# RC245775 Darfield Solar Farm

## Transport Assessment Review

<b>Prepared for</b>	Selwyn District Council
<b>Job Number</b>	SDC-J086
<b>Revision</b>	A
<b>Issue Date</b>	20 February 2025
<b>Prepared by</b>	Mat Collins, Associate Transportation Engineer
<b>Reviewed by</b>	Dave Smith, Technical Director

Figure 2.1 AGTM06 100 km/hr turning warrant assessment, reproduced (with additional line added) from the Transport Assessment.

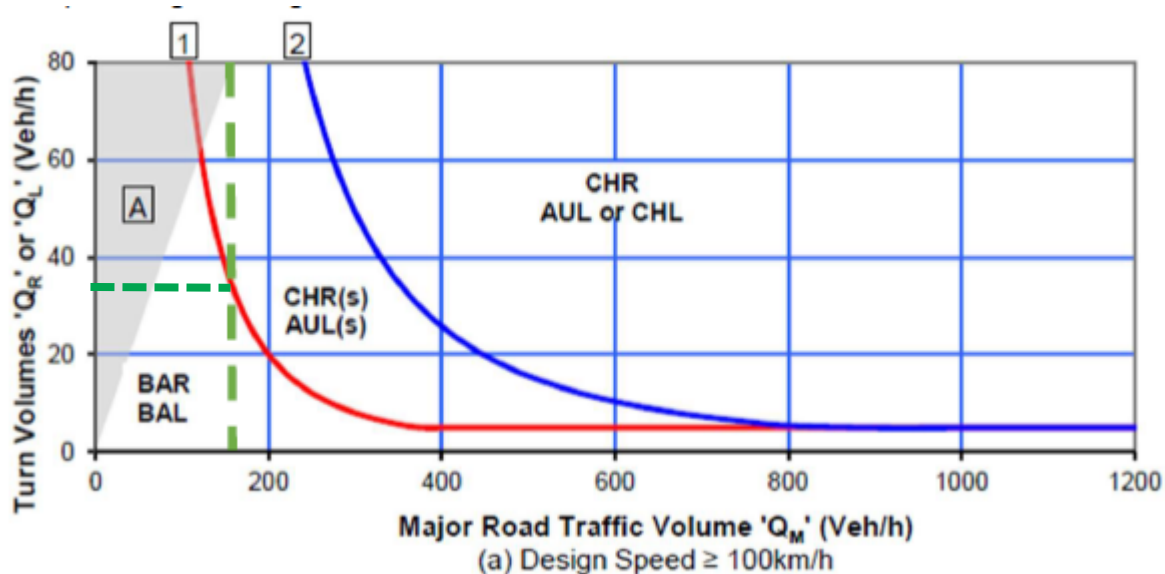
- We disagree with the TA conclusion that short Channelised Right Turn bays (CHR(s)) are not necessary. In our view these (shown by the red line in Figure 2.1) are typically the threshold at which infrastructure improvements (or in the case of traffic management applications temporary speed reductions) are desirable. When the higher threshold of a full CHR is met (the blue line in Figure 2.1), more extensive improvements are generally sought.

- Specifically the vertical green line intersects the red line at approximately 35 vehicles per hour. This is the point at which a channelised right turn treatment is required based on the warrant assessment. We have added a dark green horizontal line to the graph to demonstrate this.

- The Transport Assessment only assesses the 7am – 8am period, when vehicle movements on SH73 are lower. After 8am hourly traffic volumes on SH73 are closer to 250 to 300 two way vehicle movements per hour, as shown in Figure 2.3. At this volume a CHR(s) and a CHR would be required when right turns exceed approximately 10 veh/hr and 40 veh/hr respectively

Figure 2.2 SH73 travelling north, showing lane blockage from right turn vehicle (Source: Google Maps).

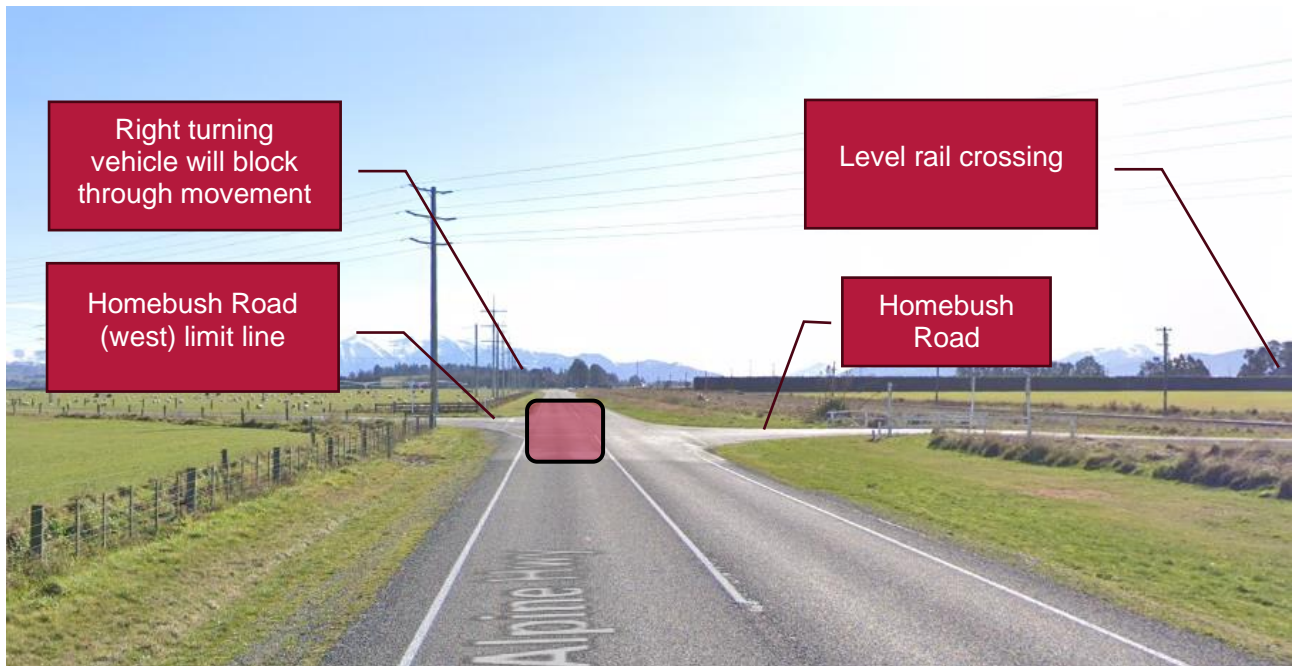
- Drivers travelling north on SH73 would be required to stop on SH73 if there is a right turning vehicle into Homebush Road, as there is no seal widening/lane widening at the intersection that would otherwise allow these drivers to pass to the left of the right turning vehicle, refer to Figure 2.2.

**Figure 2.4 NZTA Planning Policy Manual Diagram E.**

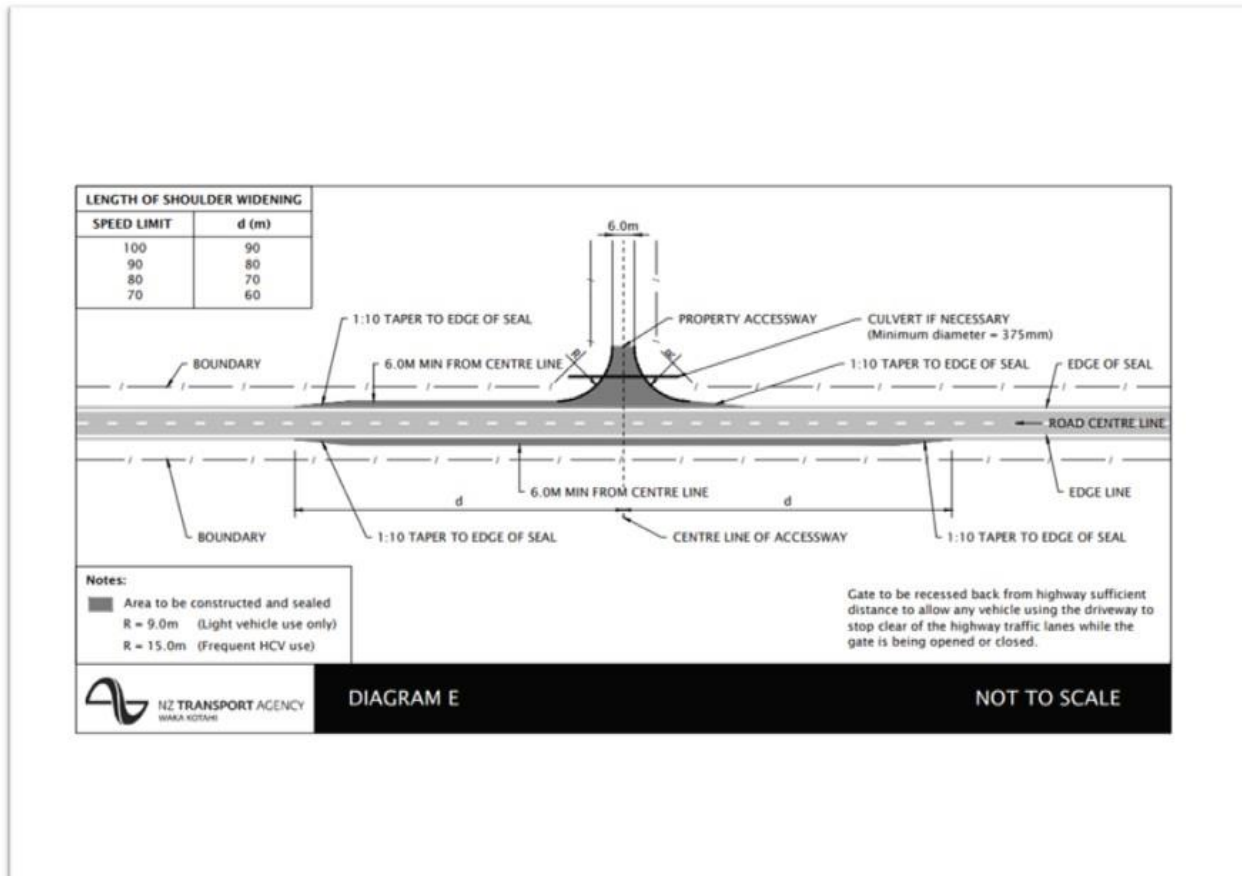
Following this meeting, Don McKenzie confirmed that the applicant would provide seal widening in accordance with NZTA Planning Policy Manual Diagram E, shown in Figure 2.4, which provides for a BAR.

The seal widening goes some way towards addressing our concerns about safety effects that the SH73/Homebush Road intersection, but in our view additional mitigations should be provided, such as warning signage and temporary speed limit reductions and this can be achieved through the implementation of a construction Traffic Management Plan (TMP).

xx. Prior to the commencement of construction on the site, the Consent Holder shall upgrade the SH73/Homebush Road to include seal widening on the western side of SH1, in accordance with NZTA Planning Policy Manual Diagram E, at the expense of the Consent Holder.

Figure 2.5 AGTM06 80 km/hr turning warrant assessment

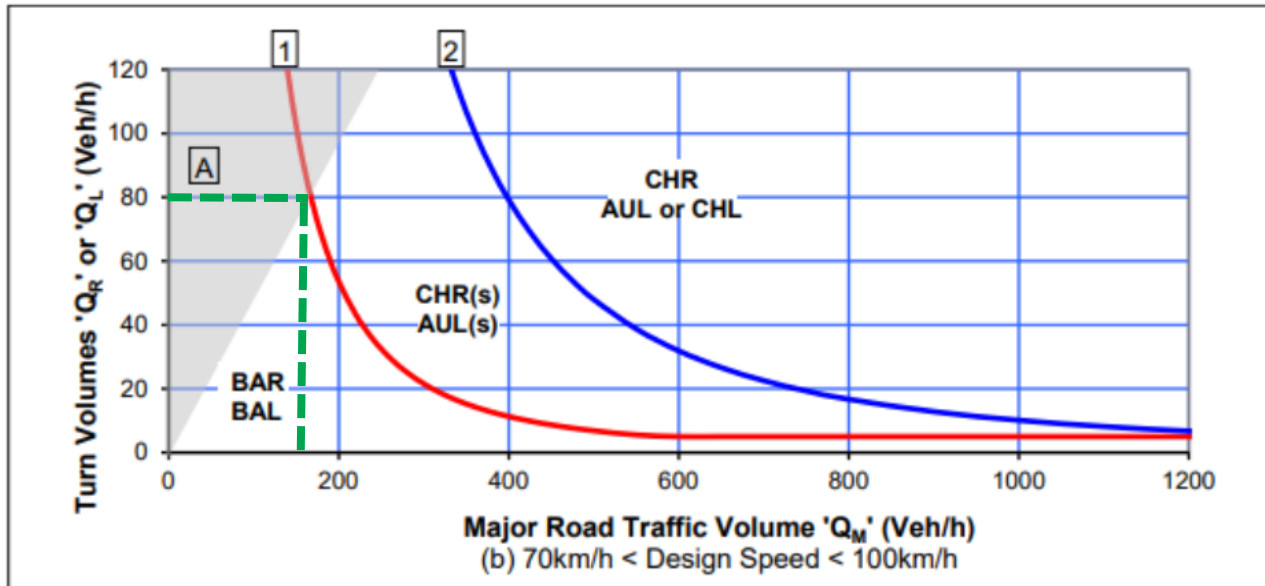
identify the hazard, decelerate accordingly and use the basic right turn treatment offered by the applicant. The corresponding Austroads warrant graph which reflects posted speed limits of 80 km/hr and 90 km/hr is included in Figure 2.5. The green line shows the applicant's proposed 80 right turning vehicles per hour between 7-8am.

Unlike the applicant's 100 km/hr assessment in Figure 2.1 it is noted that the green line does not extend past the red curve in Figure 2.5. This means that the short channelised right turn treatment is not required if a slower speed environment were adopted. We recommend that at the times that more than 35 right turning vehicles are anticipated per hour, a temporary speed reduction is implemented on SH73 in the vicinity of the intersection to mitigate the road safety risk and align with the Austroads guidance. This can in our view simply be included as part of the CTMP and in practical terms would require the installation of a temporary variable messaging sign (VMS) either side of the intersection for the duration of construction. NZTA's Speed Management Guide<sup>1</sup> provides information relating to the installation of temporary or semi-permanent infrastructure including variable speed limit signage which is typically installed in the vicinity of schools but would also be appropriate in this context.

(d) Nature and duration of any temporary traffic management proposed including the ongoing use of temporary warning signage and a temporary speed reduction on SH73 to 80 km/hr near the SH73/Homebush Road intersection, to be operational at times when the number of right turning vehicles exceeds 35 vehicles per hour. It is noted that any such traffic management measures would be subject to the approval of NZTA; and
